DESIGNED MCP	REVISED - ADDENDUM A 02/22/2013	STATE OF ILLINOIS DEPARTMENT OF TRANSPORTATION	LIGHTING PLANS - DIEHL ROAD		F.A.P. RTE. 336	SECTION (112 & 113) WRS-6	COUNTY DUPAGE	TOTAL SHEETS 734	SHEET NO. 483
DRAWN MLB	REVISED -		SCALE: AS SHOWN	SHEET NO. 7 OF 8 SHEETS	STA.	TO STA.	LT-12		CONTRACT NO. 60R31
CHECKED MCP	REVISED -		ILLINOIS FED. AID PROJECT						
DATE 09/01/2012	REVISED -

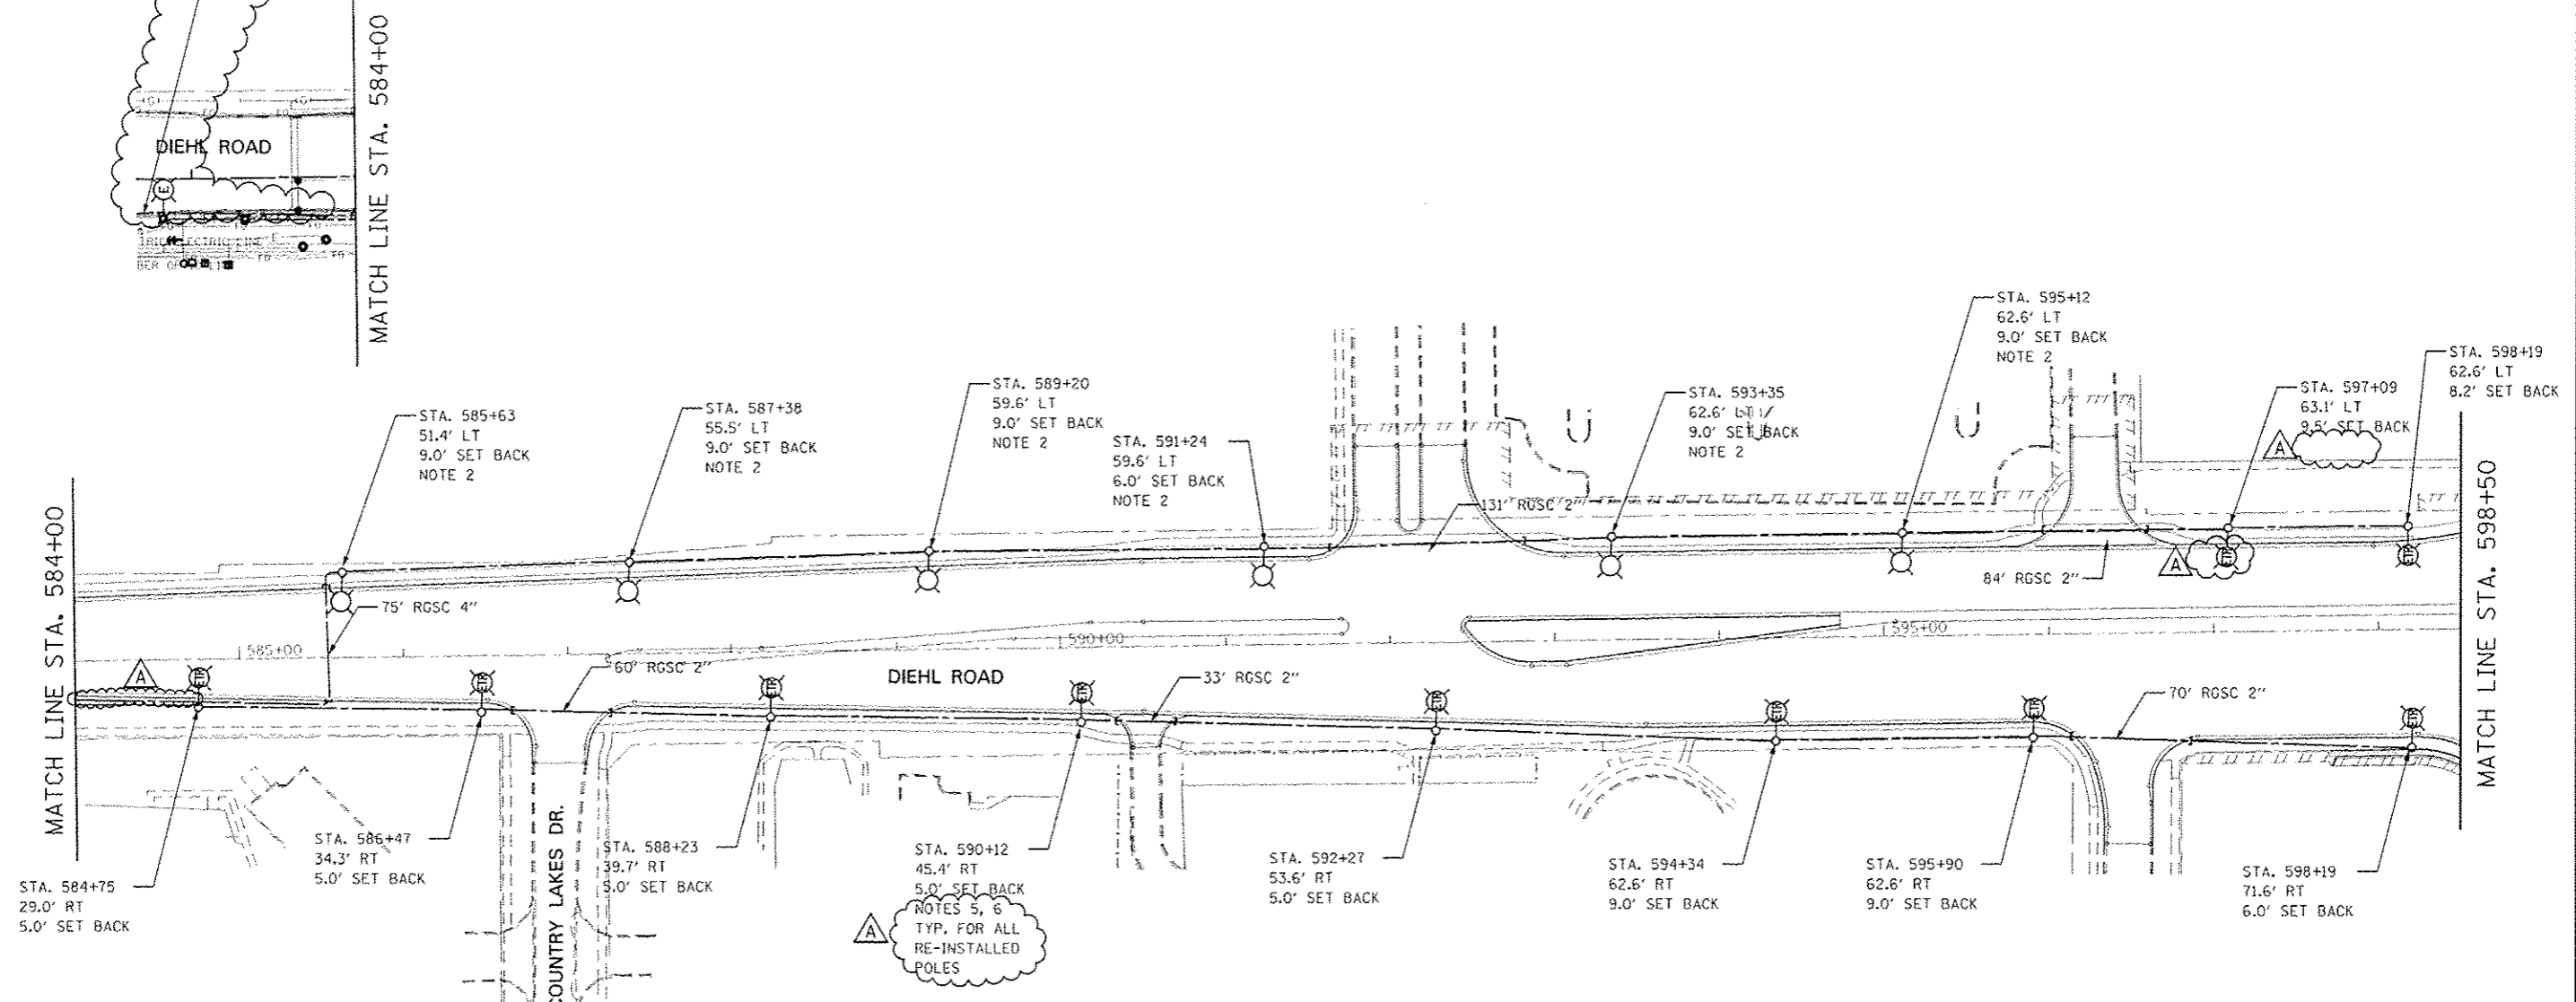
UNIT DUCT, 600V, 4-1C NO.6, 1/C NO.6 GROUND, (XLP-TYPE USE), 1 1/4" DIA. POLYETHYLENE SHALL BE RUN BACK TO CONTROLLER #018A FOR NORTH OF DIEHL RD LIGHTING. (APPROX. 550' EXTRA-RUN NOT SHOWN)
